PLANNING COMMITTEE – THURSDAY 14th March 2024

22/1764/FUL - Demolition of existing building and erection of retail food store, (Use Class E(a)), with associated access, parking and amenities at World Of Water, Hempstead Road, Watford, Hertfordshire, WD4 8QG

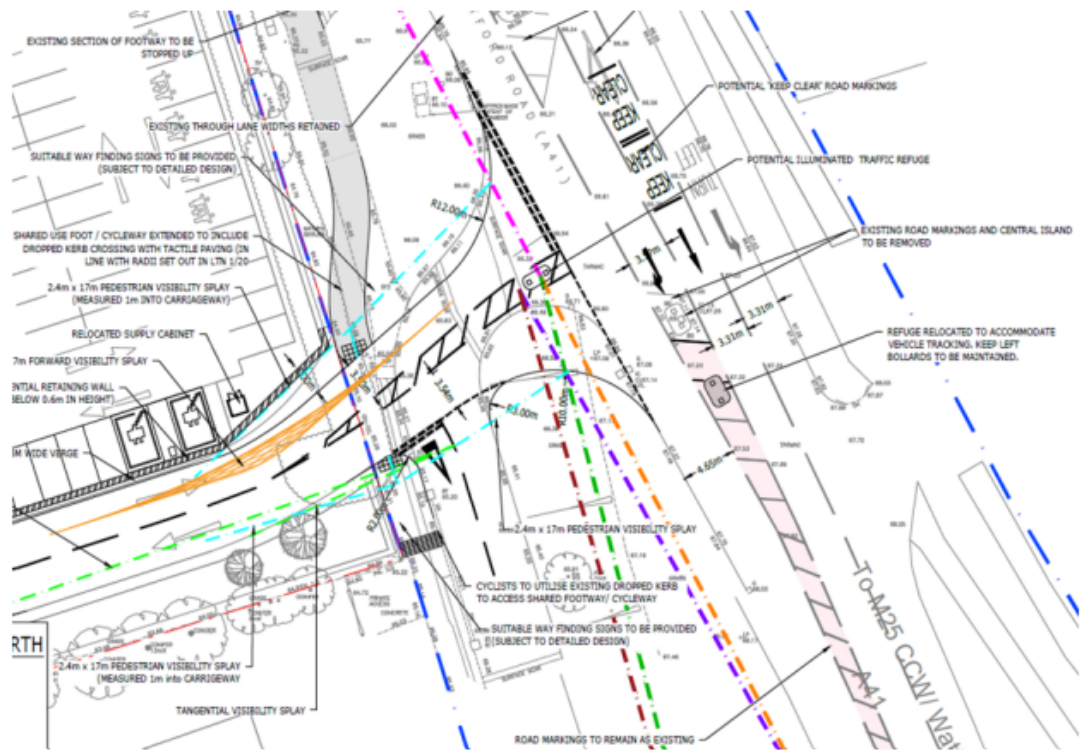
The above access presents a number of engineering challenges with the proposed foodstore usage to which the applicant's transport consultant has responded to, subsequent to comments made by the Highway Authority. This has included comments on visibility (both horizontal and vertical), vehicular access for large vehicles, geometry and turning into the site from both directions.

The Highway Authority has noted that safe and suitable access will need to be provided for goods vehicles servicing the proposed foodstore, that satisfactory visibility is ensured (in particular towards Hunton Bridge) and active travel is promoted.
